Our ref: 12791
Council ref: A006924541

RE: RESPONSE TO INFORMATION REQUEST SECTION 13.2 OF THE DEVELOPMENT ASSESSMENT RULES FOR DEVELOPMENT PERMIT FOR A CHANGE APPLICATION (OTHER CHANGE) – MATERIAL CHANGE OF USE – FOOD AND DRINK OUTLET OVER 1840 WYNNUM ROAD WYNNUM WEST QLD 4178 FORMALLY KNOWN AS LOT 1 ON RP155373

Figure 5 - Vegetation Management Plan

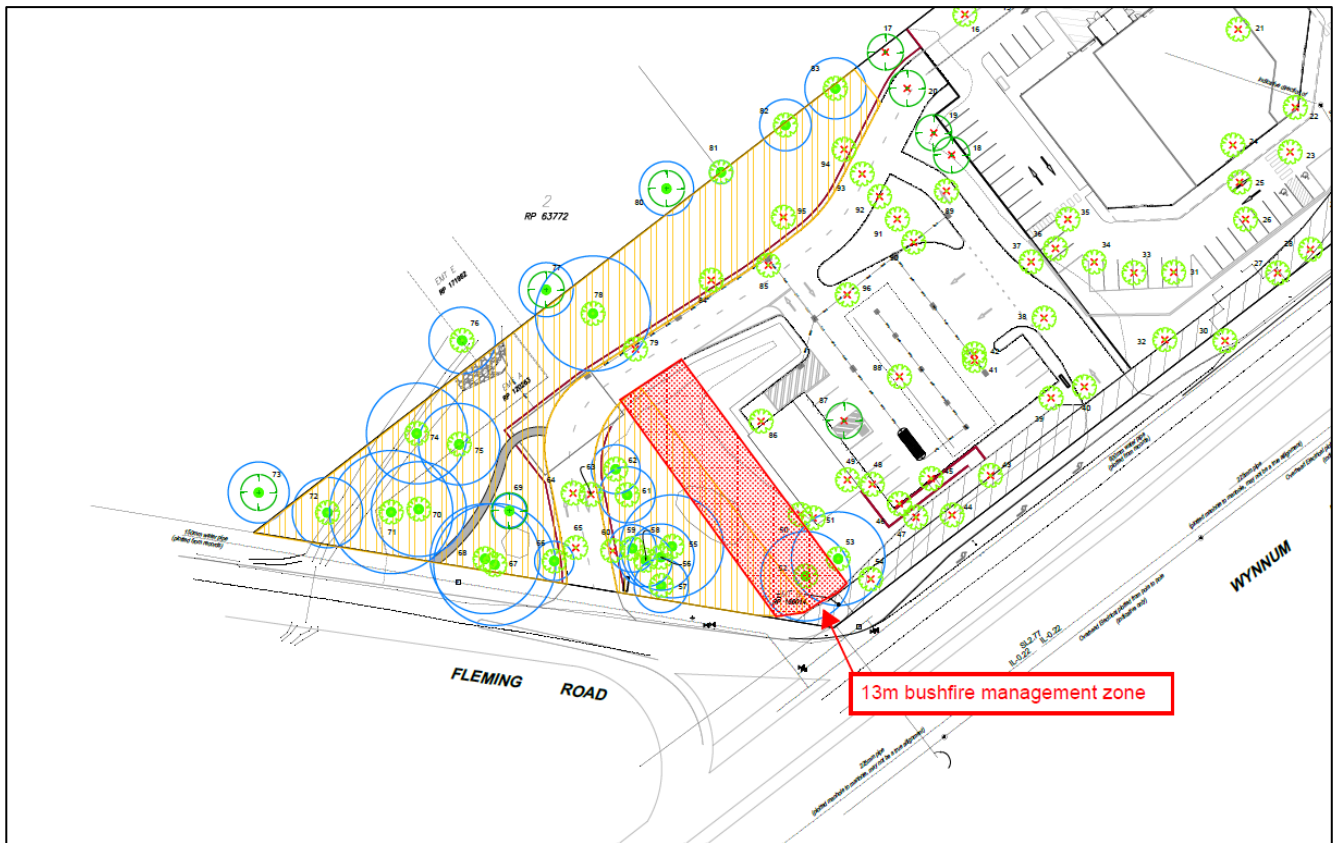
1. *The proposed development is inconsistent with the intended outcomes of the Overall outcome 2(c), 2(d), 2(j) and 2(k) of the Rural residential zone code and 3(c) and 3(f) Hemmant-Tingalpa neighbourhood plan code. The proposed intensification of use at the subject site results in a de facto centre, which does not align with the intent of Brisbane City Plan 2014. Whilst it is acknowledged that the previous approval for Service station at Stage 1 included a food component, this use was ancillary to the Service station use and was not approved as a standalone food and drink outlet. In addition, the proposal is considered to undermine the viability of the nearby neighbourhood centre, given the site is located within 400 metres of an existing neighbourhood centre and within 1,000 metres of a district centre.*

The ecological value is recognised, and this remains undisturbed as part of this development application, with the previously approved vegetation and rehabilitation management plan retained. When viewed from Fleming and Wynnum Roads the emphasis is placed on large established trees which complement the rural designed food and drink outlet built form. Please see the screenshot below of the approved Vegetation Management Plan demonstrating the retention of ecological value for the site (*Figure 2*).

Figure 8 – Pedestrian Circulation - Bayer Stevens

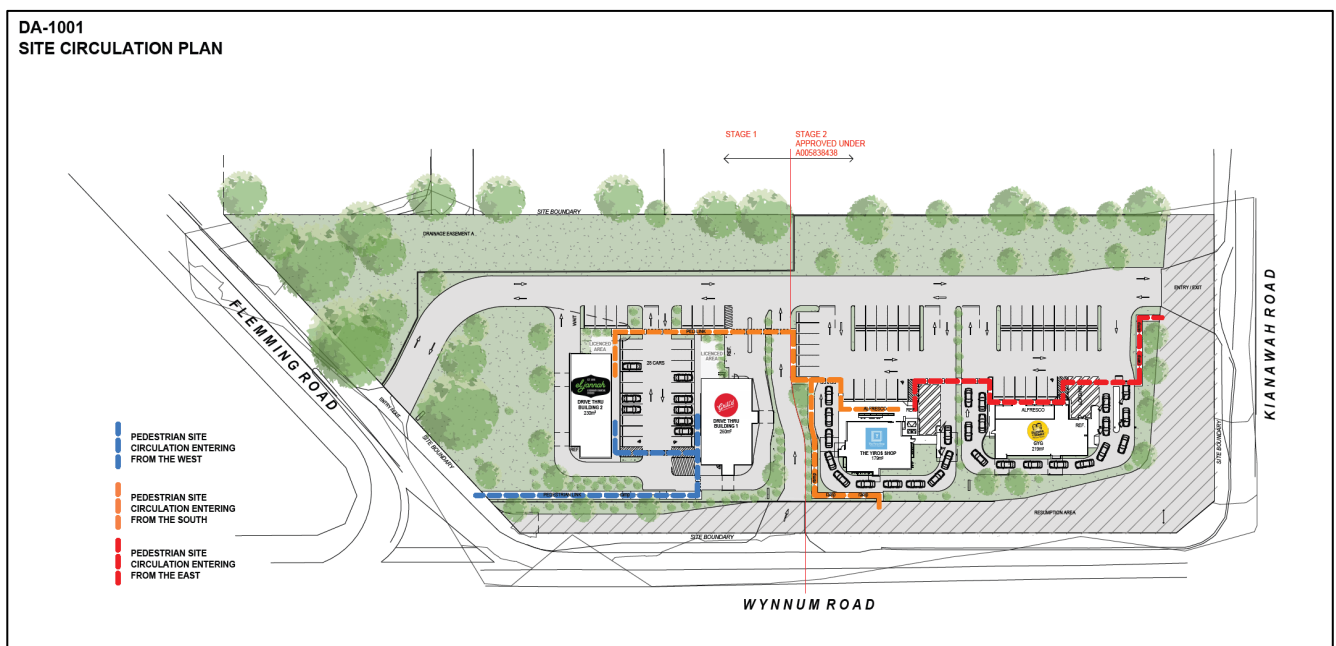
6. *The current design does not appropriately locate outdoor dining area to enhance the public realm in accordance with AO7 of the Centre or mixed use code. Additionally, the proposal results in minimum of 2 'road' crossings through car movement zones due to the sub-optimal arrangements of the pedestrian pathway, that does not address pedestrian connectivity, movement, and safety from the street to the buildings, as per AO45 of the Centre or mixed use code.*

- a) *Submit amended built form configuration that locates the drive through circulation behind the buildings allowing for connection of the public realm to the entry points, outdoor dining, and building directly from the street to the buildings, and without the need to pass through car dominated areas for safe pedestrian movement.*

Please see **Attachment A – Architectural Plans** prepared by Bayer Stevens which has introduced a Site Circulation Plan, showing pedestrian movements moving fluidly through the site from Kianawah Road, Wynnum Road and Fleming Road frontages.

Additionally, the loading for the drive-thru is relocated to remove conflicts.

Figure 10 – Revised Landscape Design – Saunders Havill

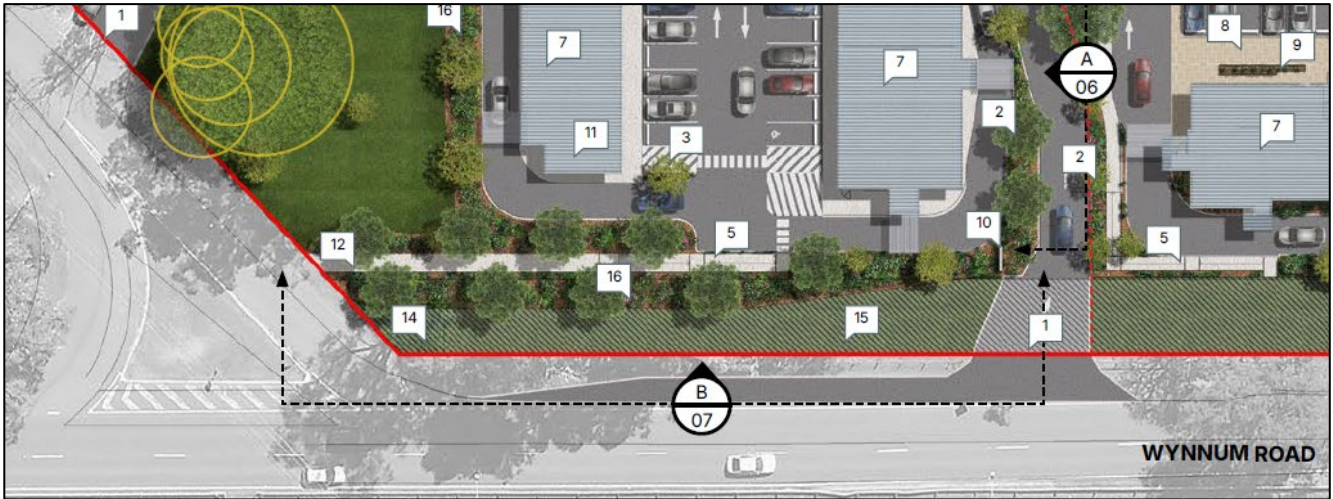
10. *The provided Landscape Concept Plan indicates a narrow landscape buffer that lacks any shade trees along the edge of the pedestrian path on the frontage, to effectively screen or soften the significant hardstand and car parking area from the streetscape. Provide an amended Landscape Concept Plan that increases the landscape buffer along the edge of the pedestrian path to a minimum of 2m and incorporate large subtropical shade tree planting and a varied palette of shrubs and groundcovers, to contribute to a comfortable pedestrian environment or support a high level of subtropical amenity in accordance with PO55, PO56, PO57 and PO58 of the Centre or mixed use code.*

Please see **Attachment A & I** – Architectural Plans and Landscape Concept Plan prepared by Bayer Stevens and Saunders Havill. During the meeting with Brisbane City Council, we understand pedestrian permeability between public and private space is a priority. The applicant has amended the design along Wynnum Road with additional planting to buffer the drive-thru area to incorporate safer design practices for pedestrian movements. Larger subtropical shade trees have been incorporated into the deep planting areas to soften the hardstand areas and the built form from all road frontages.

Figure 11 – Previous Approved Vegetation Management Plan – S5 Environmental

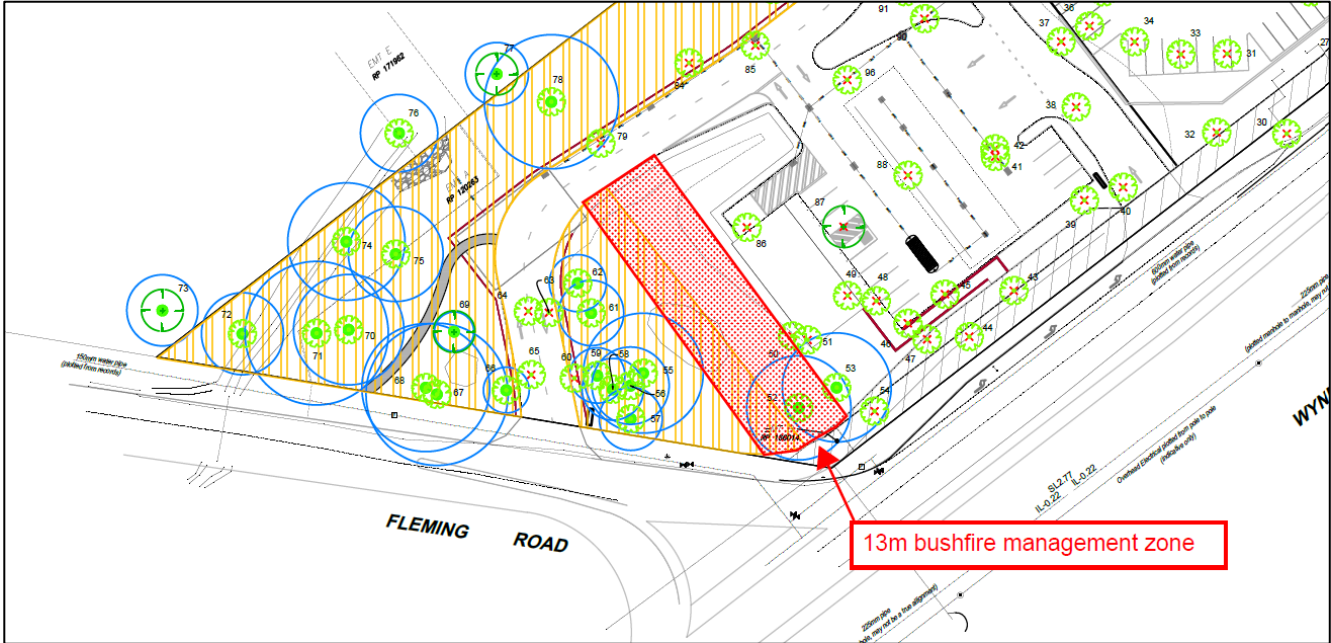
12. *The revised development layout will result in changes to previously approved plans that identify vegetation for retention/removal and rehabilitation areas, likely resulting in a reduced impact to these values. Additionally, the submitted plans do not identify the approved 13m bushfire management setback that was shown on previously approved plans and conditioned bushfire management setback that was shown on previously approved plans and conditioned.*

- a) *Provide revised Tree Retention/Removal Plans and Concept Rehabilitation Plan demonstrating that the proposed development will not result in any additional impact to existing ecological values within mapped areas of high ecological significance/high ecological significance- strategic. Revised plans must also identify the required 13m setback from potentially hazardous vegetation, in accordance with previous approvals.*

The proposed development generally follows the original development footprint, with the exception of a small portion of the El Jannah Food and Drink Outlet, please see the screenshot below of the dotted outline of the previous approved footprint.

Within this revised development footprint, as shown in the screenshot below from the Approved Vegetation Management Plan prepared by S5 Environmental, there are no trees in the expansion of the existing footprint. There is no further requirement for an amended Tree Retention Removal Plan as this does not alter the originally approved trees to be retained and removed, please see the screenshot below from the Approved Vegetation Management Plan.

Attachment A – Architectural Plans has incorporated the Bushfire Management Zone (13m) area.
